AMENDMENTS TO THE DRAWINGS:

Amendments to the Drawings

FIG. 17A

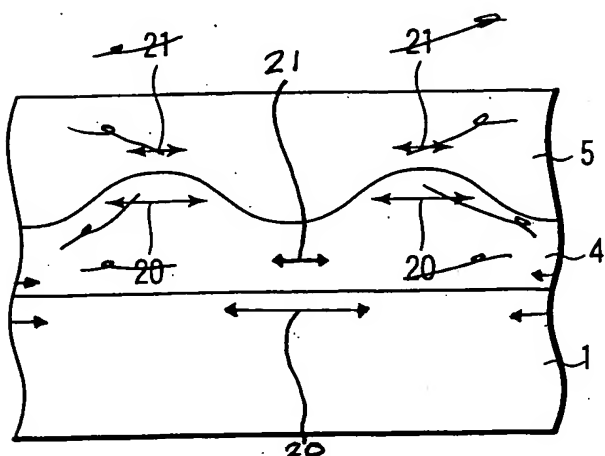
The attached sheets of drawings includes (i) amendments to Figure 17A to correct obvious mistakes and (ii) amendments to Figure 17B to correct obvious mistakes.

Figures 17A and 17B are hereby amended to correct obvious mistakes. Channel current region 20 and tunnel current region 21 were either misplaced or not shown in original Figures 17A and 17B, as would be obvious to one of ordinary skill in the art upon reading the specification. For example, Figure 14 represents an example of a “fifth embodiment” that is described in the specification at page 33, line 23, to page 36, line 24. Figures 17A and 17B are described as “cross-sectional views showing a memory cell according to a modification example of the fifth embodiment” in the specification as originally filed (pg. 36, lines 5-7). The specification further states that “[t]he memory cells of the modification example can obtain the same effect as the fifth embodiment” (pg. 36, lines 20-21). One of ordinary skill in the art, upon reading the specification, would understand that channel current region 20 and tunnel current region 21 are properly shown as in amended Figures 17A and 17B, such as to be consistent with the specification and Figure 14.

The original specification states that channel current region 20 is located in silicon substrate 1, and that tunnel current region 21 is located in tunnel insulating film 4. For example, the specification explains that channel current region 20 is “a region ... where channel current flows in the cell transistor operation” (pg. 34, lines 10-12), and Figure 14 shows that channel current region 20 is located in “silicon substrate 1.” The specification also explains that tunnel current region 21 is “a region ... where tunnel

current flows in the write/erase operation” (pg. 34, lines 13-14), and Figure 14 shows that tunnel current region 21 is located in “tunnel insulating film 4.”

Furthermore, one of ordinary skill in the art would know, in view of the original specification, that channel current region 20 and tunnel current region 21 should be at the particular locations shown in amended Figures 17A and 17B. Applicants advise that one of ordinary skill would know that (i) the channel current flows through an inversion layer at a surface region of the substrate 1, (ii) the channel current is concentrated in sections of increased vertical electric field intensity, and (iii) the regions of increased vertical electric field intensity are sections of the surface region of the substrate 1 that are arranged under the smaller thicknesses of the tunnel insulating film 4. Applicants also advise that one of ordinary skill would know that the (i) the tunnel current flows through the tunnel insulating film 4, (ii) the tunnel current is concentrated in sections of increased vertical electric field intensity, and (iii) the regions of increased vertical electric field intensity are sections of the tunnel insulating film 4 having smaller thicknesses. Thus, the particular locations of channel current region 20 and tunnel current region 21 that are shown in amended Figures 17A and 17B correct obvious mistakes in the original versions of these drawings.

In addition, the illustration in amended Figures 17A and 17B of channel current region 20 as larger than tunnel current region 21 is supported in the original specification. For example, the specification explains that “the channel current region 20 has the larger area than the tunnel current region 21” (pg. 34, lines 15-16), and this relationship is also shown in Figure 14. Thus, the amendments to Figures 17A and 17B correct obvious mistakes and add no new subject matter.
